Addendum No.: 1

Date Of Addendum: 09/07/18

Master Plan Phase III Renovations and Additions
Norwalk Community College
188 Richards Ave.
Norwalk, CT
BI – CTC – 467

11 VAV HOT WATER COIL PIPING ARRANGEMENT
MS.04 NOT TO SCALE

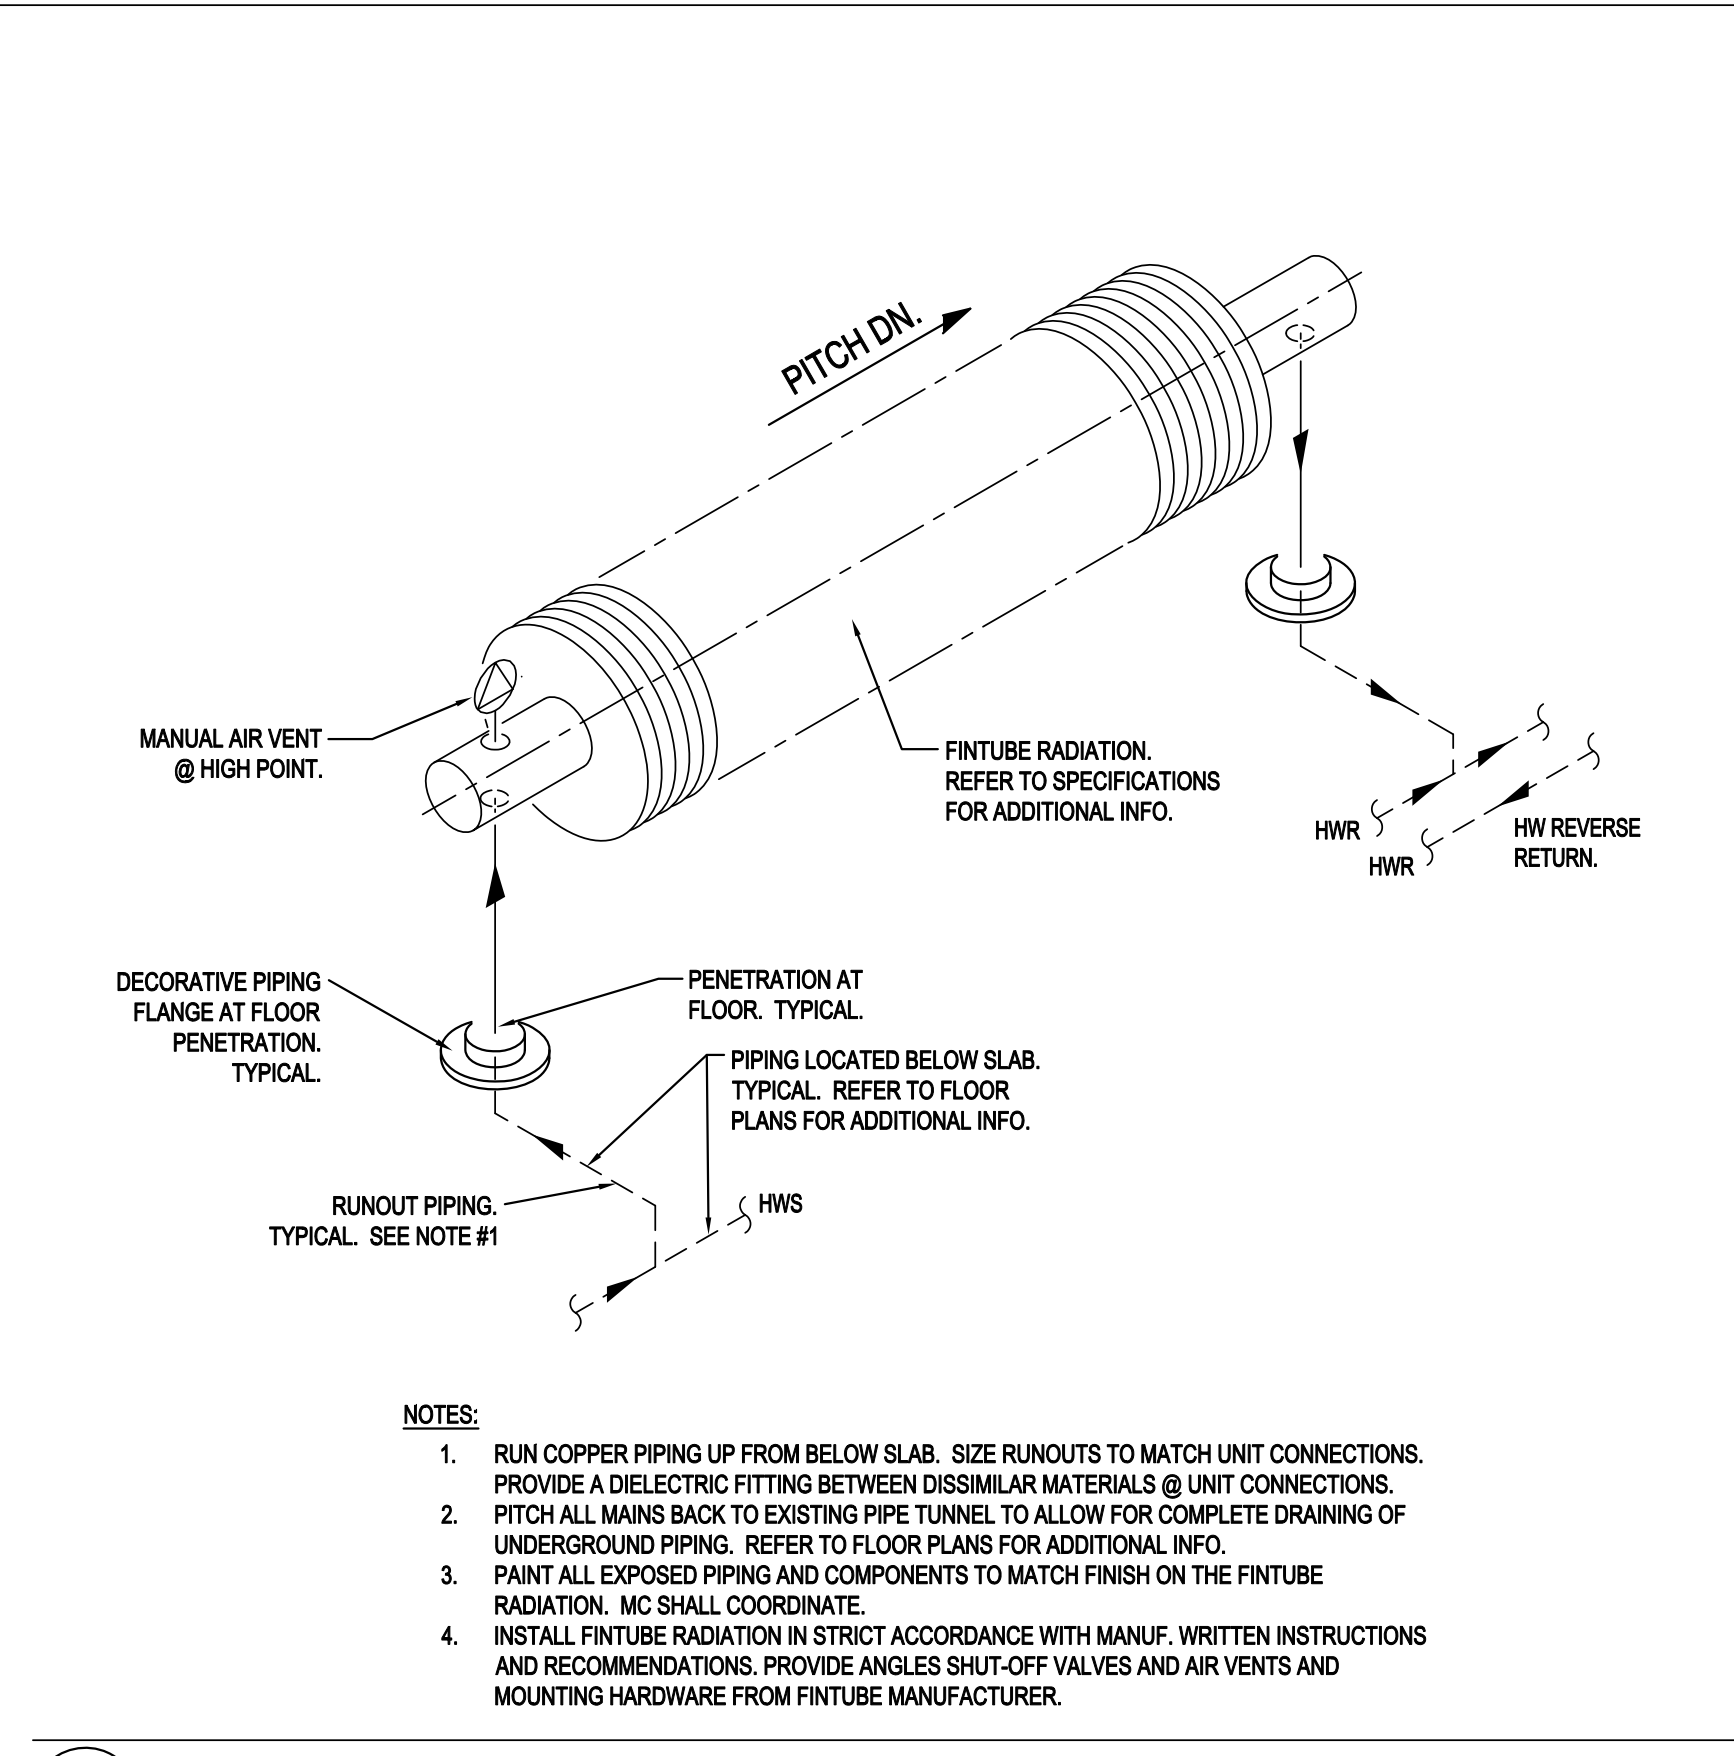
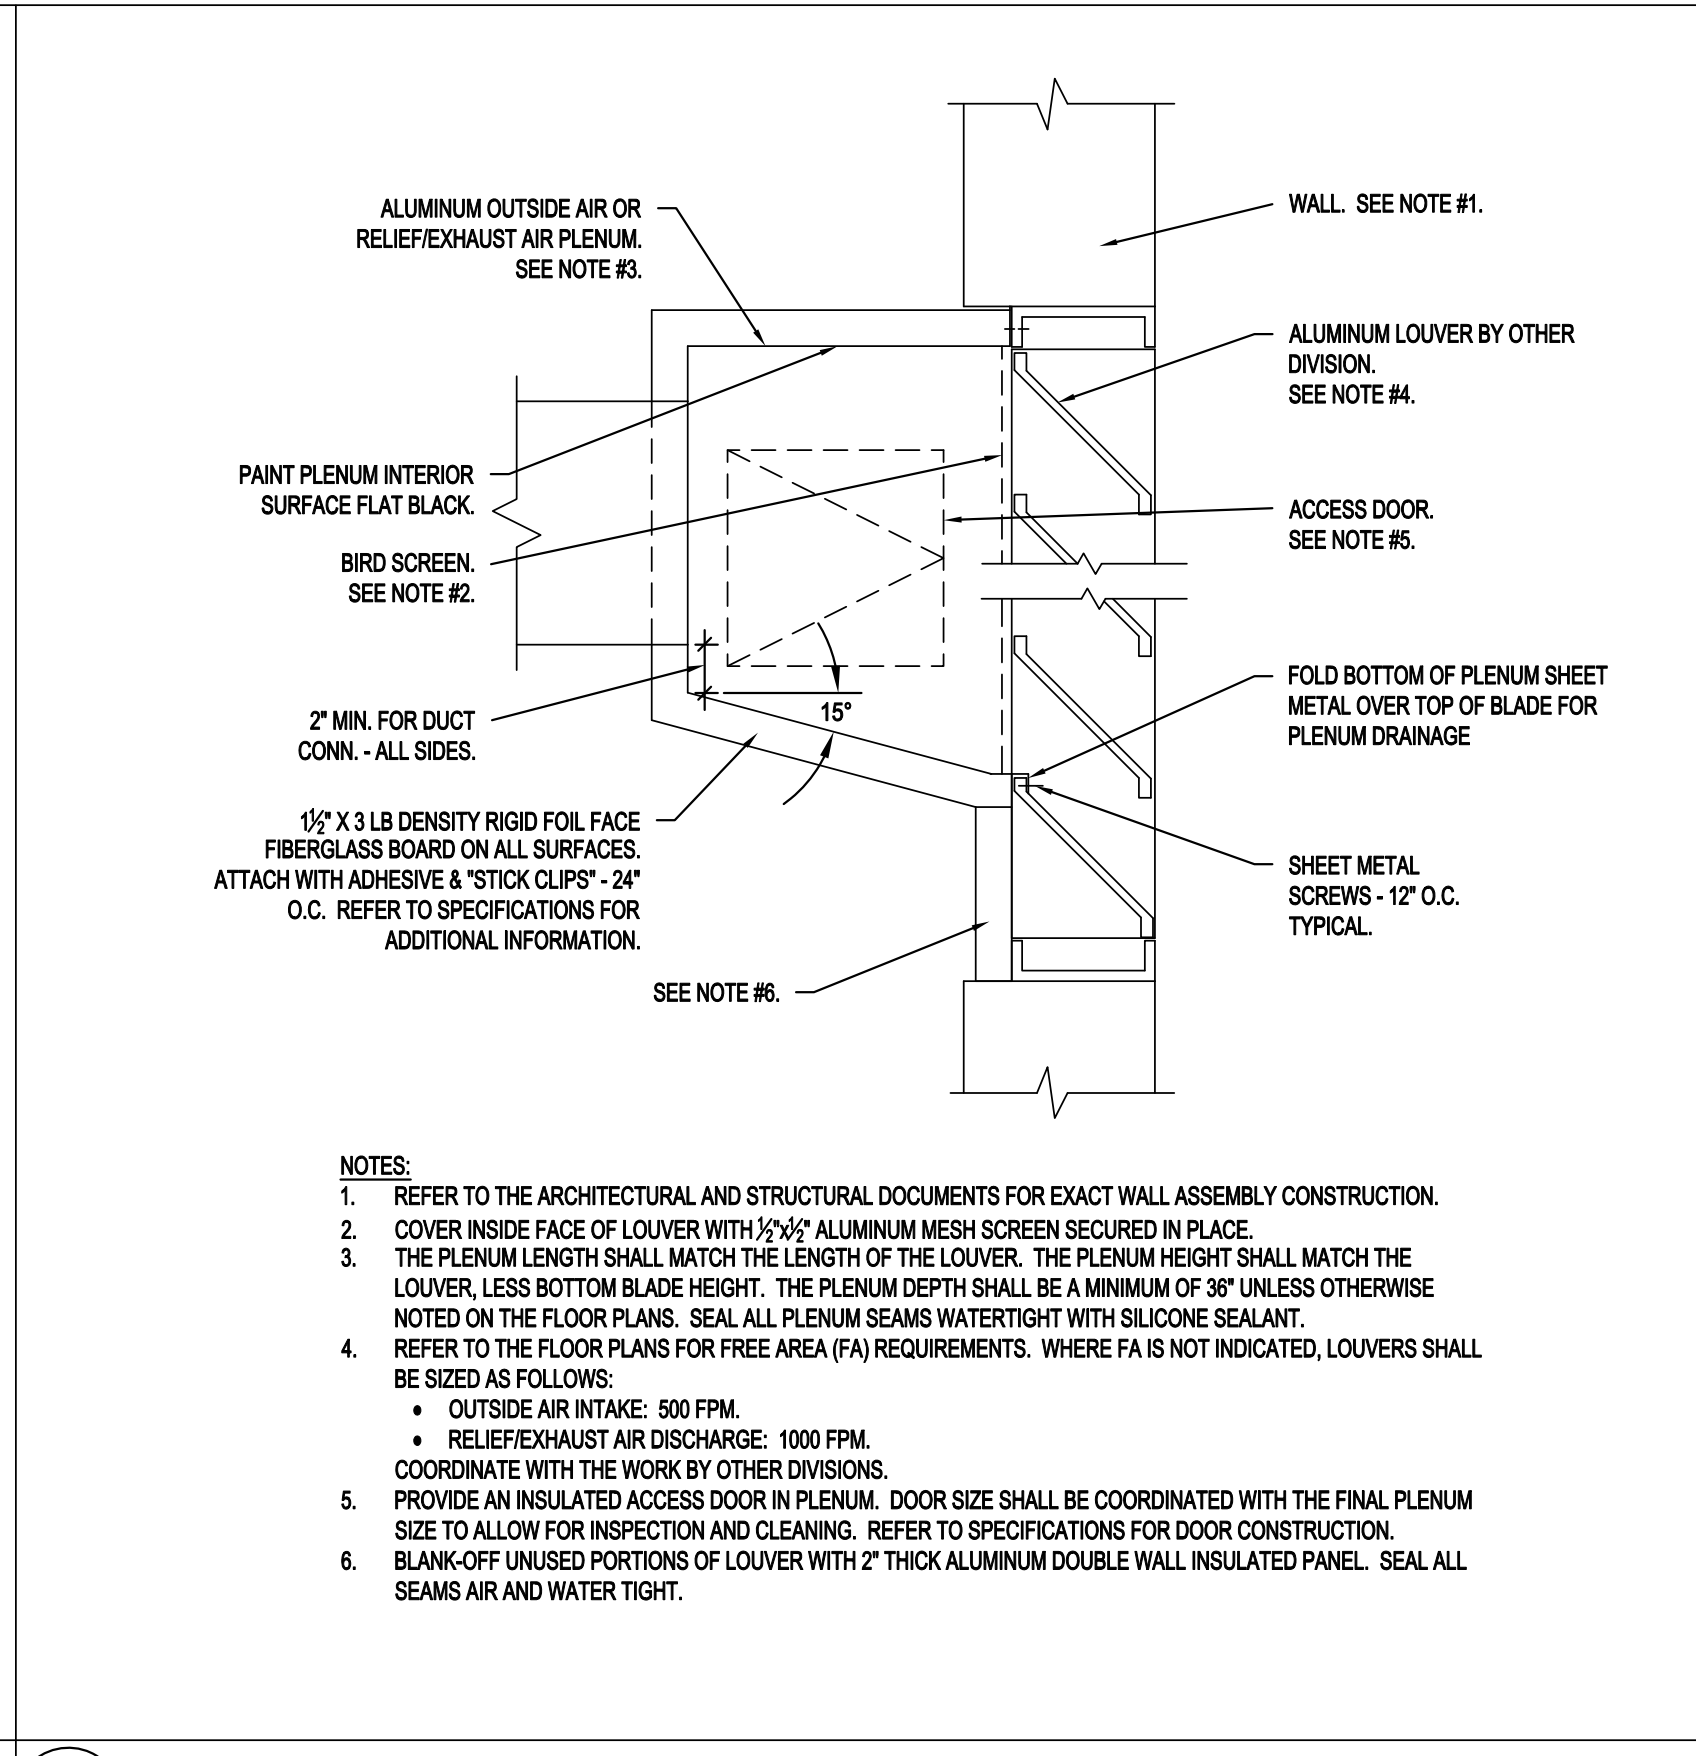
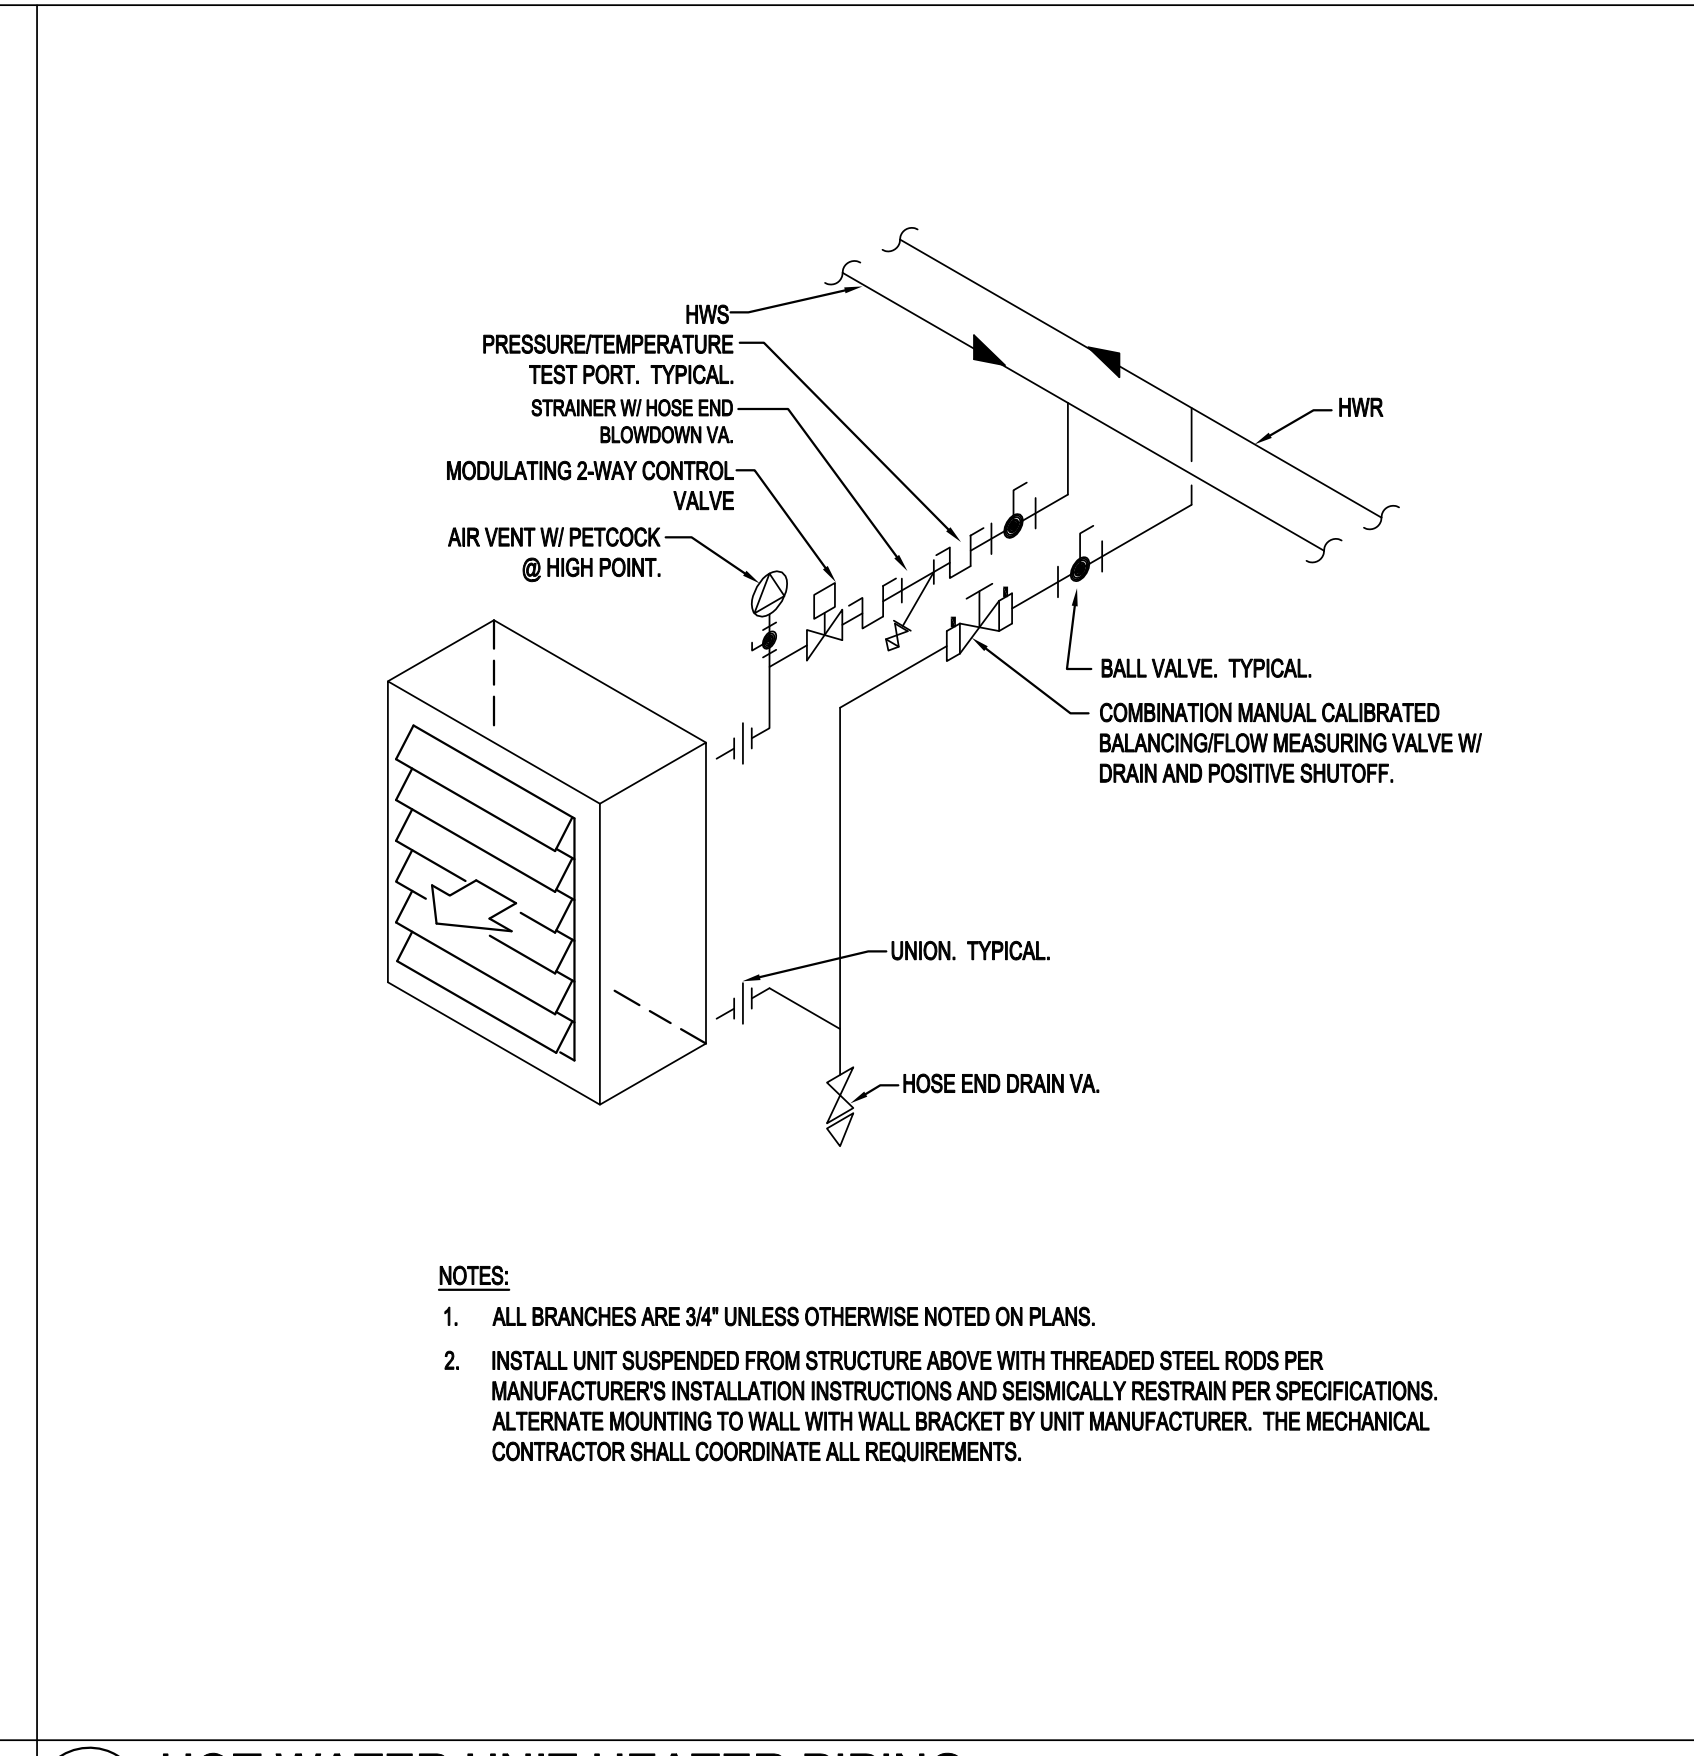
M5.04 – re-issued, Addendum No. 1, 09/07/18: Revised detail 11 to clarify VAV clearance requirements. Revised detail 7 to clarify duct lagging framing.
